Item ID: D407-667-105TRN Accept *N900040100* Setup Start *NS1*
 Revision ID: Stop *NS2*
 Item Name: Crosstube Turning Detail
 Start Date: 2/3/2015 Start Qty: 1.00 *1* Cust Item ID:
 Required Date: 2/3/2015 Req'd Qty: 1.00 *1* Customer:
 Reference:

Work Order: <u>129297</u>	DISPOSITION Rework ☐ Scrap ☐ Use-as-is ☒ Suspected Unapproved ☐	AGAINST DEPARTMENT/PROCESS Skid-tube ☐ Machining ☐ Thermoforming ☐ Large Fab ☐ Crosstube ☒ Small Fab ☐ Finishing ☐ Composite ☐ Water Jet ☐ Prod. Eng. Coord. ☐ Rec/Store/Packaging ☐ Supplier ☐ Engineering ☐ Quality ☐ Other ☐
Part No. <u>D407-667-105 TRN</u>		
NCR No. <u>15-5156</u>

DART AEROSPACE LTD		Work Order:	129297
Description: Crosstube Assembly		Part Number:	D407-667-145
Inspection Dwg: D407-667-145 Rev: C		Page 1 of 2

DRAWING NO. D407-667-145	TITLE CROSSTUBE ASS'Y (407 HIGH FWD)	REV. C	DART AEROSPACE LTD ENGINEERING ORDER		D.E.O. NO. D407-667-145-C-1	SHEET NO. SHEET 1 OF 1	SCALE NTS
DRAWN 97	CHECKED 155	MFG. APPR. 155	APPROVED 155		DE APPR. 155		
DATE 11.07.15	DATE 11.07.22	DATE 11.07.22	DATE 11/07/22		DATE 11.07.21

DETAIL P
BONDING STRAP INSTALLATION 2 PL

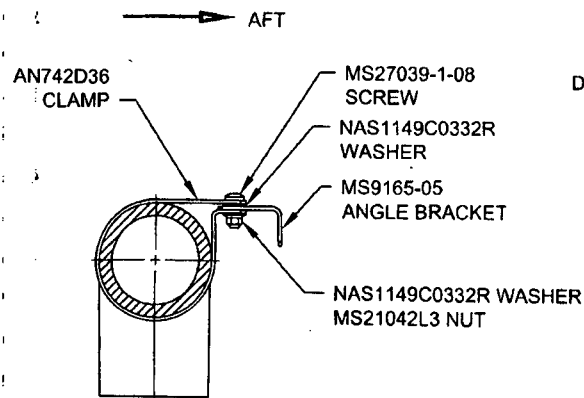
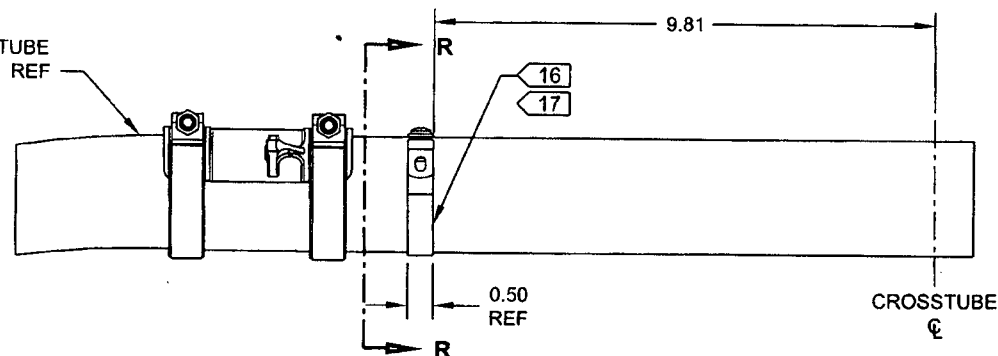
ADD ELECTRICAL GROUNDING STRAP

ITEM	QTY -145	PART NUMBER	DESCRIPTION
1	X	D407-667-145	CROSSTUBE ASSEMBLY (407 HIGH FWD)
10	2	AN742D36	CLAMP
11	2	MS9165-05	ANGLE BRACKET
12	2	MS21042L3	NUT (OR MS21042-3)
13	2	MS27039-1-08	SCREW
14	4	NAS1149C0332R	WASHER (OR AN960C10L)

- 16) MASK AREA UNDER CLAMP PRIOR TO PAINTING
- 17) SEAL EDGES WHERE AN742D36 CLAMP MEETS WITH THE CROSSTUBE USING SIKAFLEX-241/-291 OR MIL-S-8802 CLASS B2 OR PROSEAL 890 SEALANT
- 18) PERFORM RESISTANCE CHECK TO ENSURE MAX RESISTANCE IS 10 MILLIOHMS
